# UNITED STATES PATENT AND TRADEMARK OFFICE

APPLICATION NO.	FILING DATE	FIRST NAMED INVENTOR	ATTORNEY DOCKET NO.	CONFIRMATION NO.
10/618,033	07/11/2003	Yaron Keidar	50572/W112	4112
23363	7590	09/16/2010		
CHRISTIE, PARKER & HALE, LLP			EXAMINER	
PO BOX 7068			COLELLO, ERIN L	
PASADENA, CA 91109-7068				
			ART UNIT	PAPER NUMBER
			3734	
			NOTIFICATION DATE	DELIVERY MODE
			09/16/2010	ELECTRONIC

<b>Office Action Summary</b>	<b>Application No.</b> 10/618,033	<b>Applicant(s)</b> KEIDAR, YARON	
	<b>Examiner</b> ERIN COLELLO	<b>Art Unit</b> 3734

### DETAILED ACTION

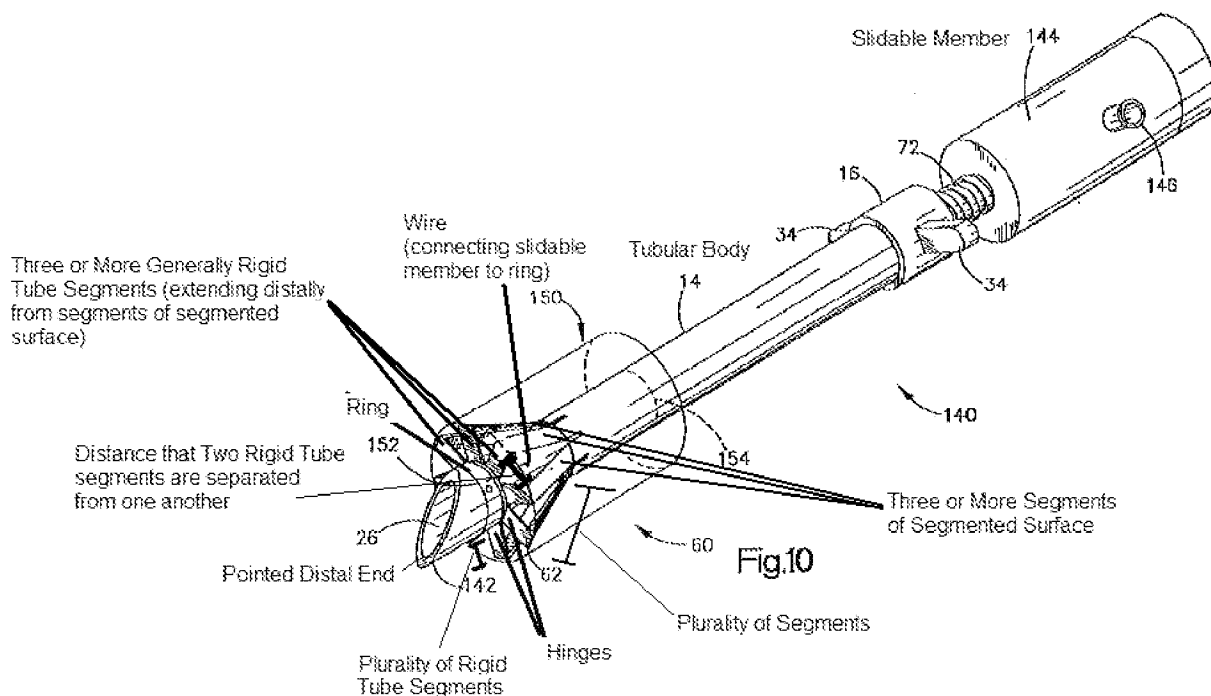
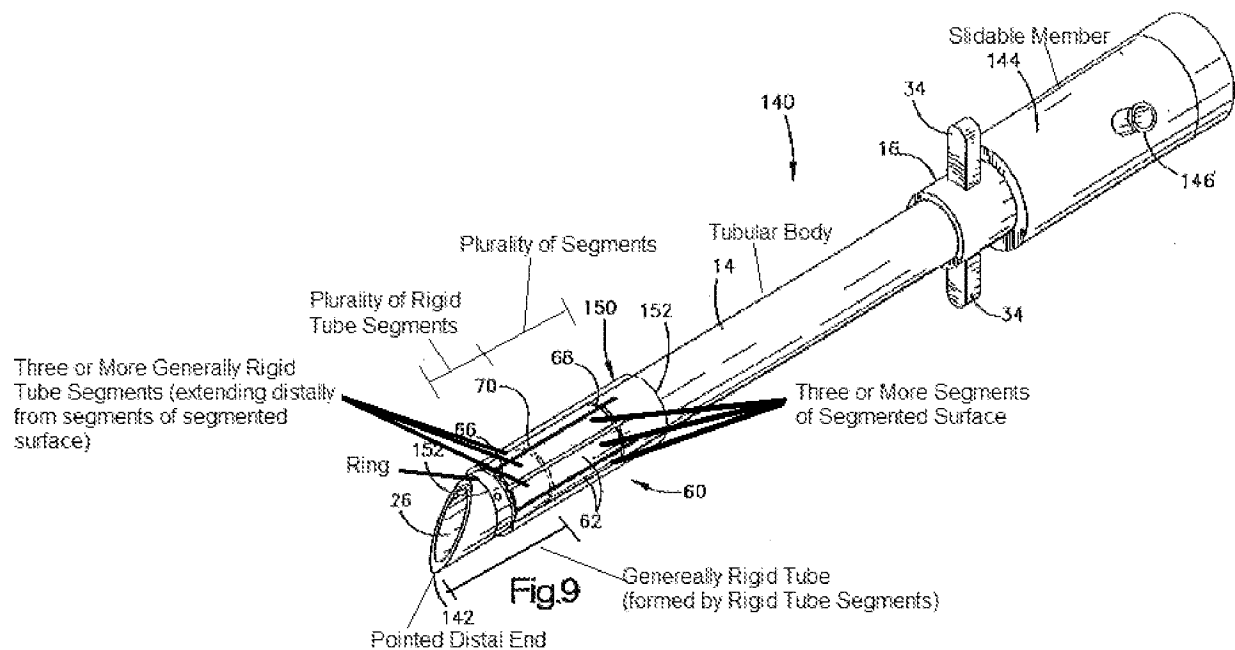
**Regarding claim 25**, Bonutti discloses a device comprising: an elongated, generally flexible tubular body (Ref 14); and a dilating tip (Ref 60) slidably mounted on a distal end of the tubular body (Ref 60, 14; wherein the distal end of the dilating tip slides relative to the distal end of the tubular body) and comprising: a segmented surface comprising a plurality of segments having proximal and distal ends (Ref 60, 62; Figures 9 and 10 see below), wherein the plurality of segments is configured to move between a closed configuration in which the segments combine to form the segmented surface (Ref 62, Figure 9 see below) and an open configuration in which the segments separate from one another (Ref 62, Figure 10 see below); a plurality of generally rigid tube

segments (Ref 62; Figures 9 and 10 see below), each tube segment extending distally from a segment of the segmented surface (Ref 62; Figures 9 and 10 see below), and wherein, when the plurality of segments is in the closed configuration, the plurality of tube segments combine to form a generally rigid tube (Ref 62; Figures 9 see below; wherein the plurality of tube segments form a portion of the generally rigid tube) having a sharp distal end configured to puncture tissue (Ref 142; wherein the generally rigid tube has a sharp distal end); and a ring (Figures 9 and 10 see below) slidably mounted to the tubular body (Figures 9 and 10 see below; wherein the ring slides relative to the distal end of the tubular body), wherein the distal ends of the segments of the segmented surface are hingedly attached to the ring (Ref 62; Figure 10 see below; wherein the distal ends of the tube segments are hingedly attached to the ring); wherein proximal movement of the ring relative to the tubular body exerts a force on the segmented surface to thereby open the segmented surface (Figures 9 and 10 see below; wherein (Ref 16) and (Ref 144) move relative to each other. Therefore when (Ref 16) is held, (Ref 144) can be rotated causing (Ref 144) to move proximally which triggers the ring to move proximally collapsing the dilating tip of the tubular body to thereby force open the segmented surface).

**Regarding claim 7**, Bonutti discloses that the dilating tip is generally funnel-shaped (Figure 10, Ref 60).

**Regarding claim 14**, Bonutti discloses a wire (Figure 10 see above; wherein the retractor body is a long pliable metallic rod and therefore is being interpreted as a wire) extending proximally from the dilating tip to near the proximal end of the tubular body (Figure 10; wherein the wire connects the ring to (Ref 144; wherein 144 is near the proximal end of the tubular body) to effect proximal movement of the dilating tip relative to the tubular body (Figures 9 and 10 see above; wherein (Ref 16) and (Ref 144) move relative to each other. Therefore when (Ref 16) is held, (Ref 144) can be rotated causing (Ref 144) and the wire (Figure 10 see above; wherein the retractor body is a wire) to move proximally which triggers the ring to move proximally collapsing the dilating tip of the tubular body to thereby force open the segmented surface).

The Examiner respectfully disagrees. As shown in Figures 9 and 10 reproduced above, Bonutti does in fact disclose three or more generally rigid tube segments extending distally from one of the segments of the segmented surface and in Figure 10, Bonutti shows an open configuration in which the tube segments part and can therefore be interpreted as being separate from each other. Since Bonutti does in fact disclose the claimed invention, the arguments are not persuasive.
